DECEMBER 18
TAP114

RPTR102 TO PC CHALLENGER FITMENT WITH FACTORY BASH PLATES.

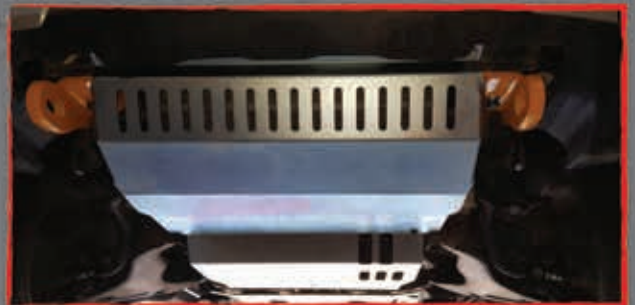
Picture above illustrates trimming required of the passenger side factory bash plate. Self explanatory once the recovery points are fitted and the bash plate sat in position.

Picture above is of the driver's side front bash plate, similar amount needs to be trimmed, again placing the bash plate back into position will show how much of this wing that needs to be trimmed. Paint cut surface to stop rust forming.

For fitment with factory bash plates ensure that there is 6mm or more clearance around the recovery point allowing for chassis deflection.
